Suspension Bolt Contacting Gray Tank

Bulletin Type:	TSB	Publication Date:	November 2023
Bulletin #(s):	23-127	Make(s):	Jayco - Entegra
Job Code(s):	9803597	Model(s):	Swift (20T)/Swift LI (20TL) Ethos (20T)/Ethos LI (20TL)
Flat Rate(s):	9803597A .10 HR – Inspection Only of Suspension Bolt 9803597B .25 HR – Inspect and Cutting Suspension Bolt	Model Year(s):	2022-2024

Incident:	Suspension bolt contacting the Gray Tank
Affected Units:	2022-2024 Jayco Swift 20T)/Swift LI (20TL); Entegra Coach Ethos (20T)/Ethos LI (20TL)
Parts List:	N/A
Misc. Tools & Supplies:	Reciprocating Saw with Metal Blade

Fig. 3

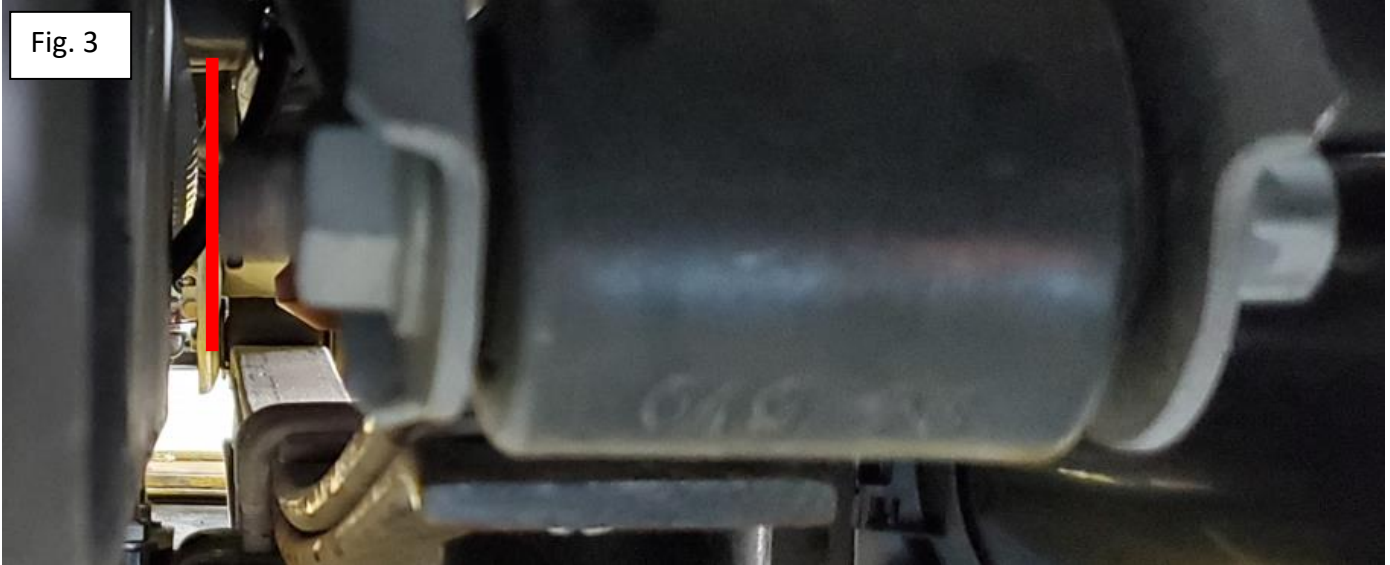
1. Using a reciprocating saw, cut the end of the suspension bolt off to create clearance between the tank and the end of the bolt. (Red line in Figure 3)
 - a. NOTE: The bolt should be cut with approximately 3-5 bolt threads exposed from the nut.
